**THERMOMASS**<sup>®</sup>  
**BUILDING INSULATION SYSTEMS**  
By Composite Technologies Corporation

AC422-0210-R1

January 18, 2010

Ref: Proposed Acceptance Criteria, AC422-0210-R1

FIGURE 1

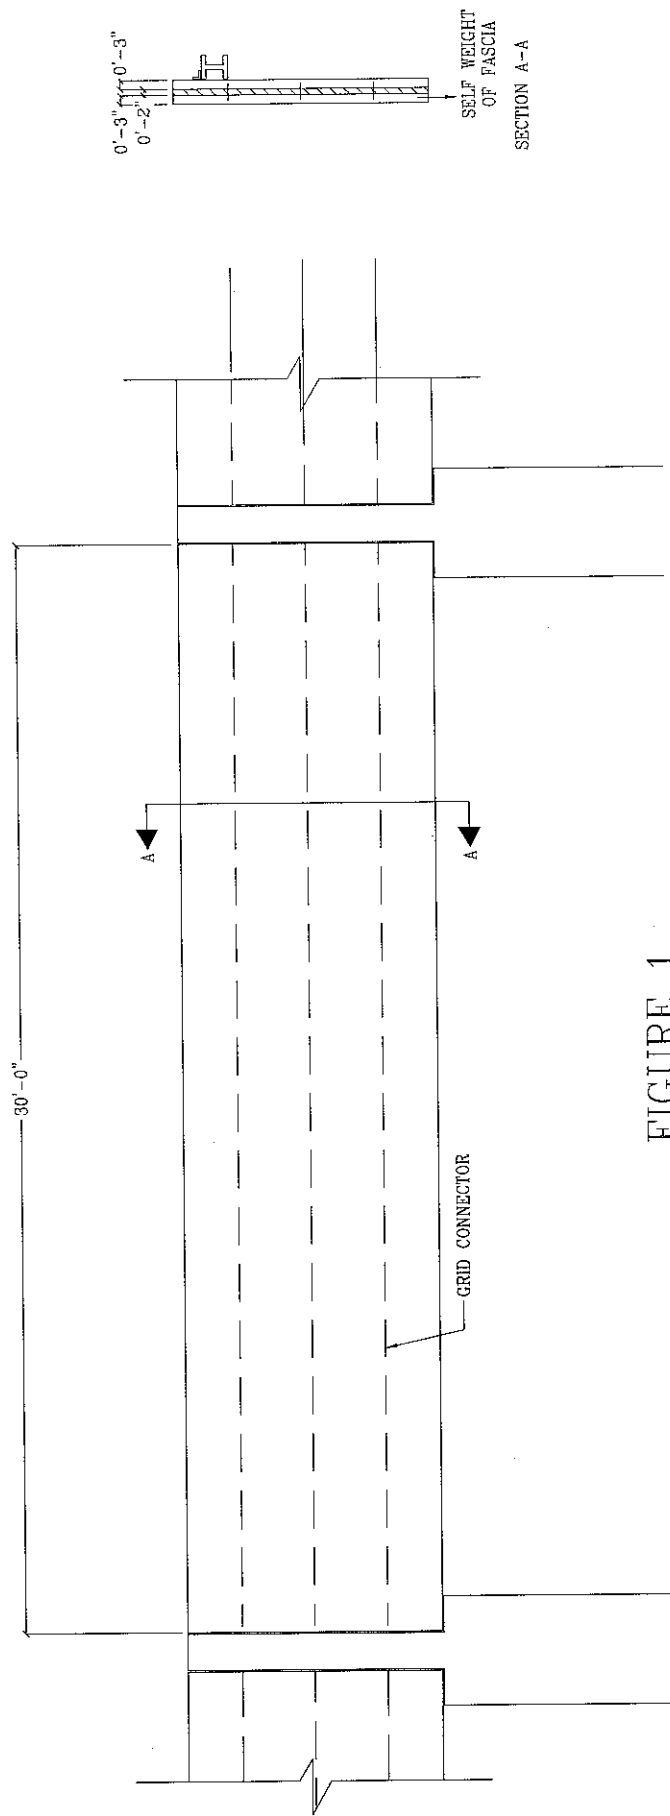
6. Also, sandwich panels are typically used as spandrel panels (horizontal dimension larger than vertical dimension) in buildings. In such panels, the shear resistance due to bending is required in horizontal direction (longer direction) and shear resistance is required in vertical direction since the fascia wythe is supported by the connector, which means the connector is subjected to shear in weak direction. Another reason for requiring weak axis shear test. See Figure 1.

FIGURE 2

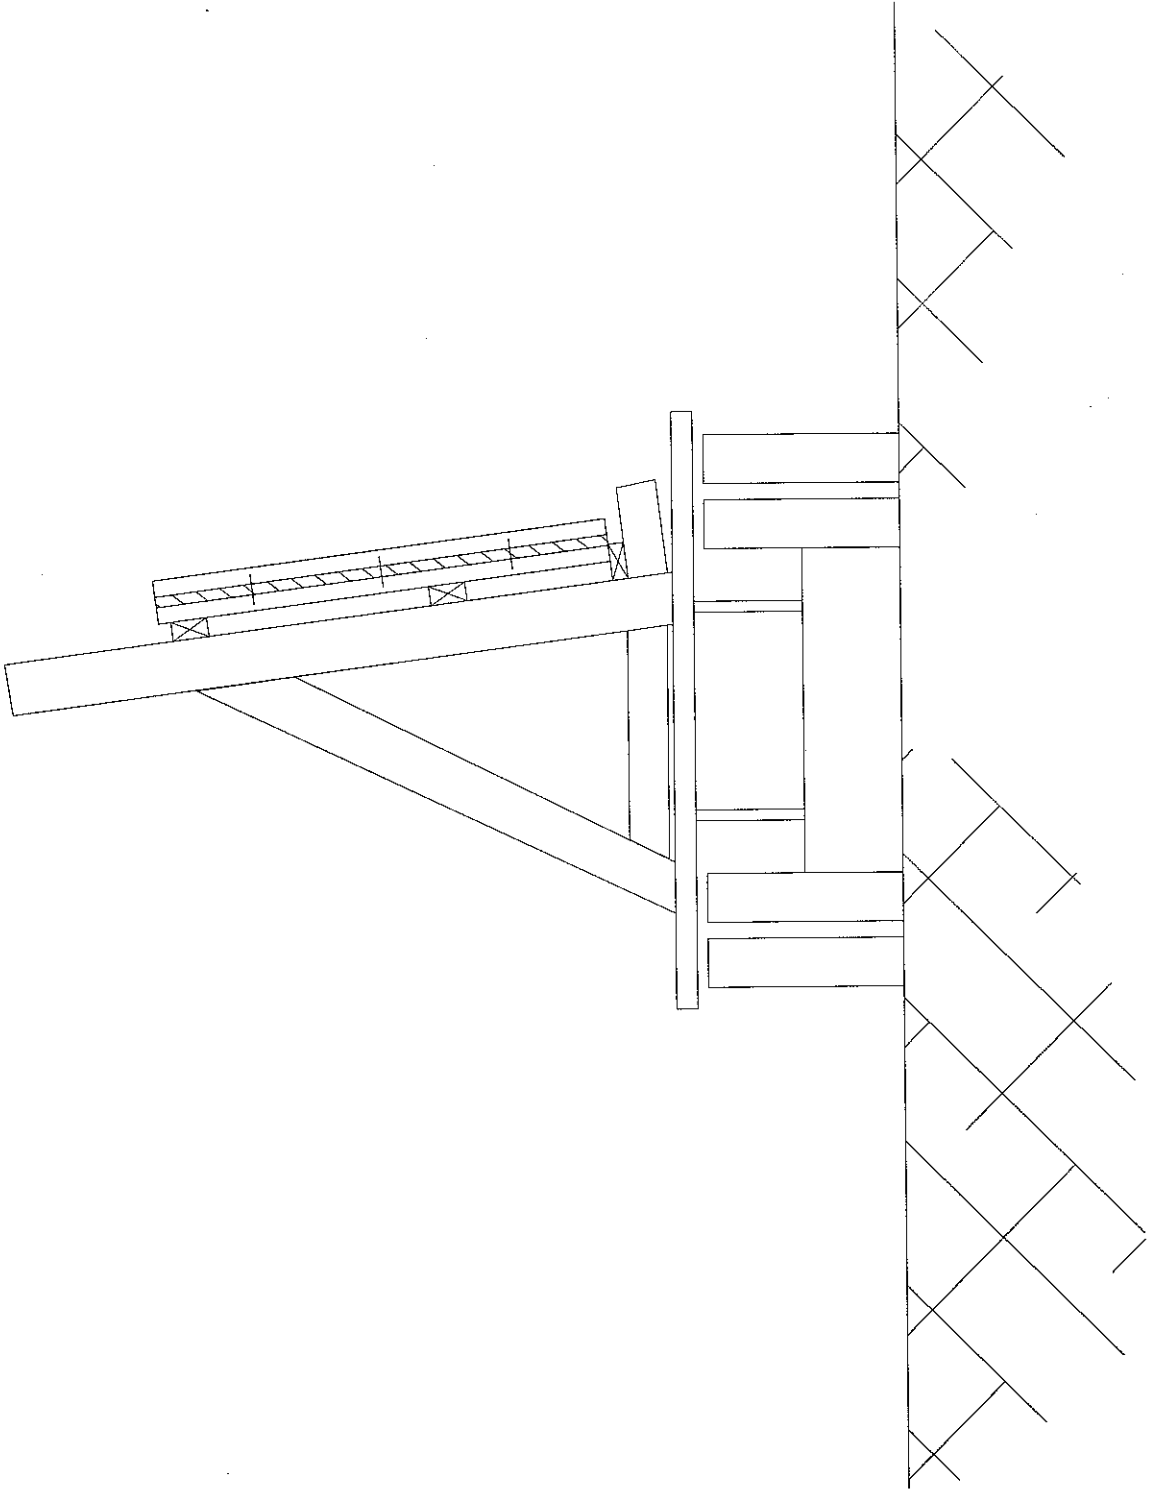
7. Furthermore, sandwich panels are often stored and transported vertically without the equal wythe support. This imparts shear load in the weak direction in the connector. Yet another reason for conducting the weak axis shear test. See Figure 2.

FIGURE 4

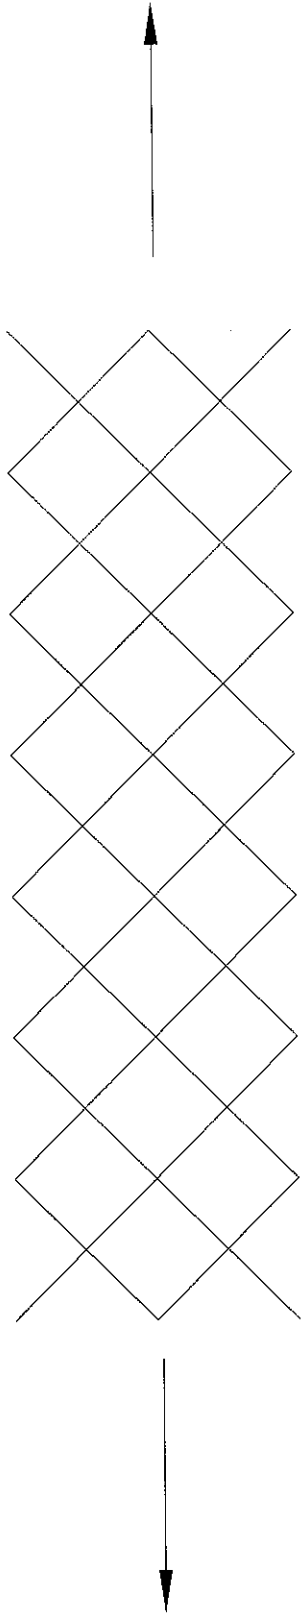
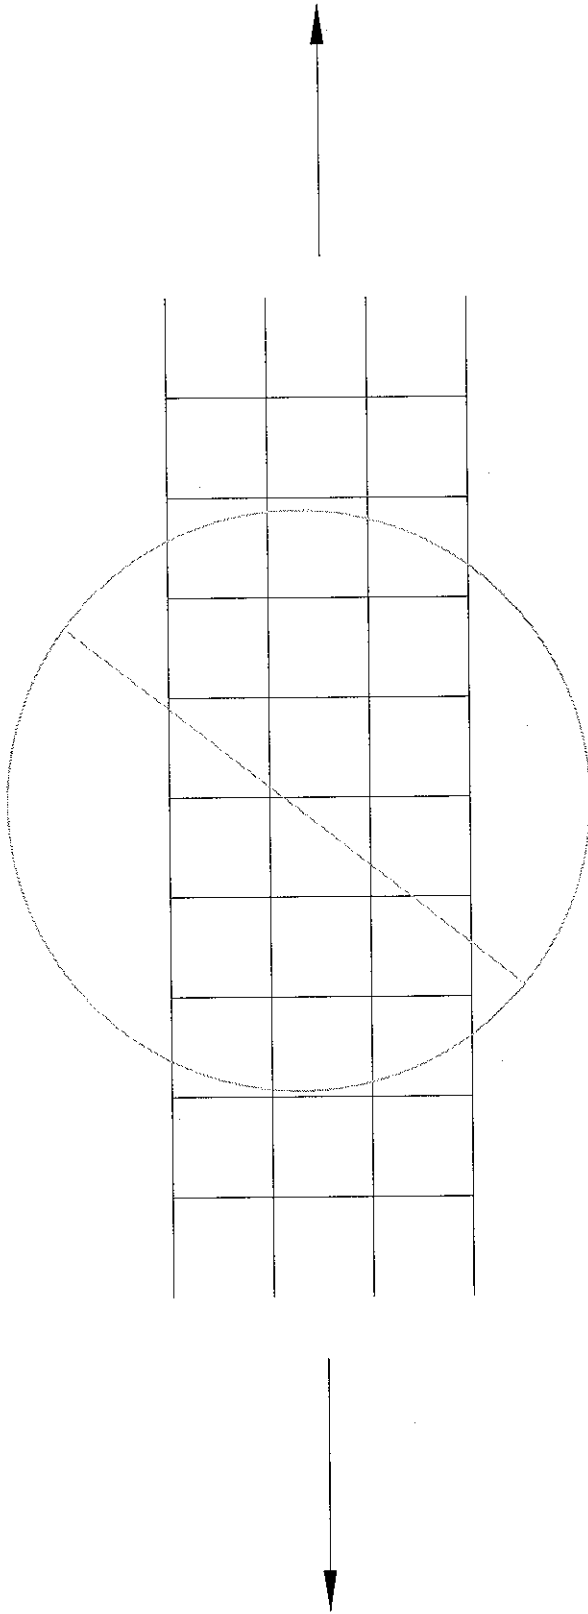
23. Also, section 4.3.1 does not define the direction in which the connector grid to be tested. As explained earlier, the grid connector is cut from perpendicular grid, and section 4.3.1 should define the tensile test is to be done at 45° to the grid, which will be along the length of the grid connector. See Figure 4.
